CITY OF ALBUQUERQUE

PLANNING DEPARTMENT – Development Review Services

RE: Winrock Town Center – Phase A- RED ROBBIN (J19D058B)
Grading Plan, Engineer's Stamp Date: 4-26-2016

PHASE A - RED ROBBIN HYDROLOGY AND HYDRAULICS

A1 DRAINAGE PLAN
SCALE 1"=20'

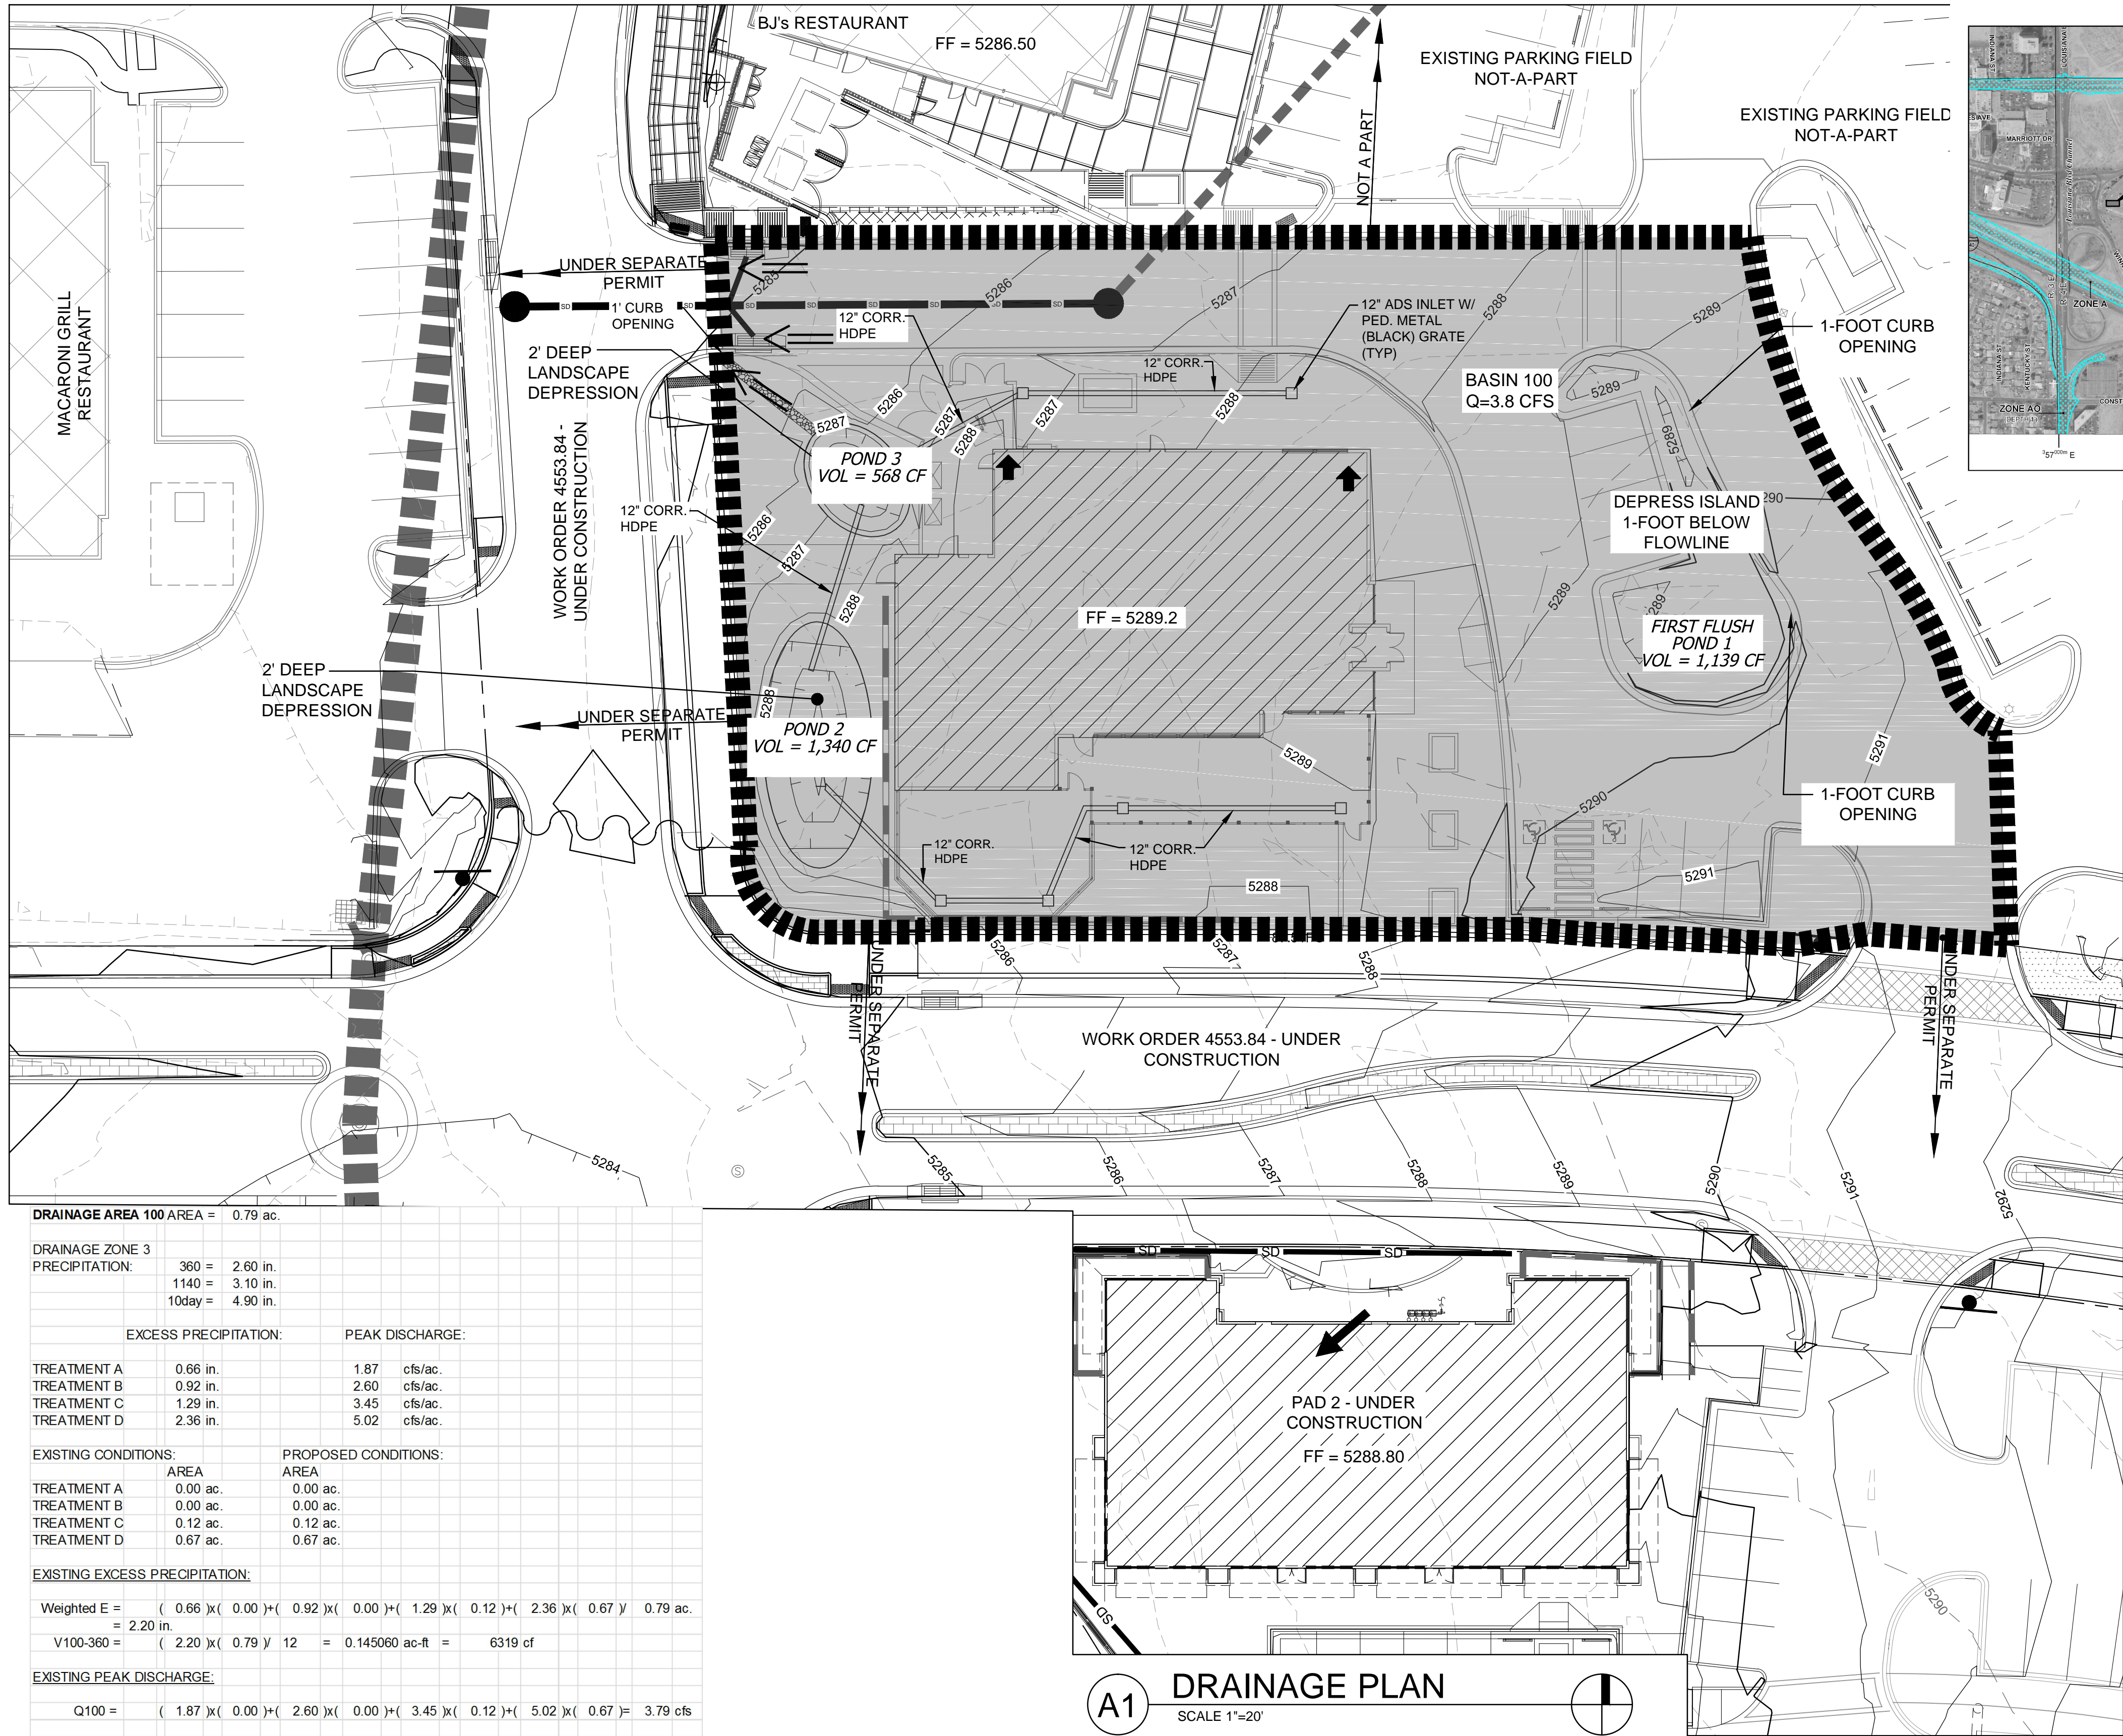
- It is preferable that the pond at NE corner of site discharges to inlet at NE corner. If this can be changed during construction, note so on the as-built plan.
